## Chapter 9

### Items 9-1-12 through 9-13-12

June 14, 2013.

**Ballot Comment and Proponent Comment Agenda- July 15-19, 2013:  
Proposals of 2012 submitted on the ICC A117.1-2009**

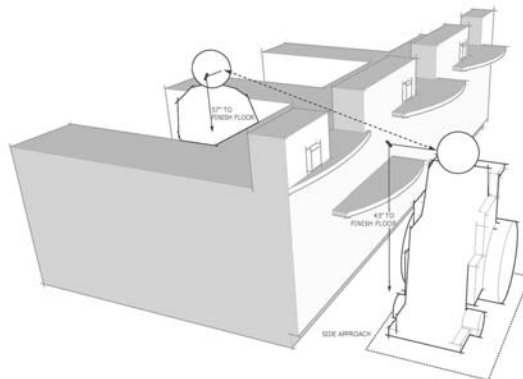
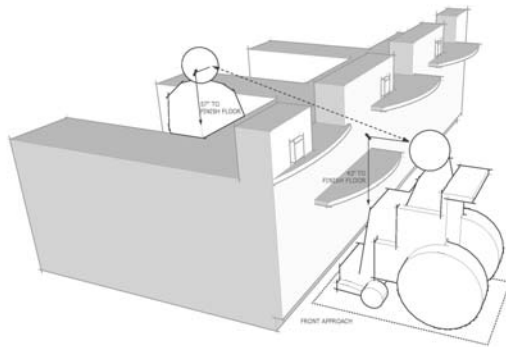
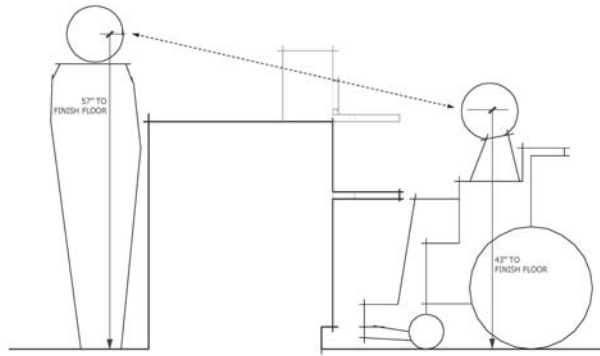
Based upon many discussion points the concerns about sales/service counter heights do not appear to be related to the accessible counter height vs. the employee counter height but rather the visibility/eye site line of an individual using a chair by an employee behind the counter.

Attached are sketches that show the eyelevel of a below average 5'-0" high employee with an eyelevel of 4'-9" working with an individual in a chair with an eyelevel of 3'-7" or what would equate to an individual 3'-11" in height. As this demonstrates an individual using a chair or a standing person of short stature is easily visible and able to work with the employee.

To further this concept I would propose the following amendment to proposal 9-7 and Section 904 that the committee took action on to codify the eyelevel/visibility locations.

**904.3.3 Visibility.** Where counters are required to be utilized by the public in interacting with personnel on the opposite side of the counter, the accessible portion of the countertop shall be located so that the public is visible at a point located 43 inches (1100 mm) above the center of the clear floor space to a point located 56 inches (1450 mm) above the personnel floor space and 3" (80 mm) behind the countertop.
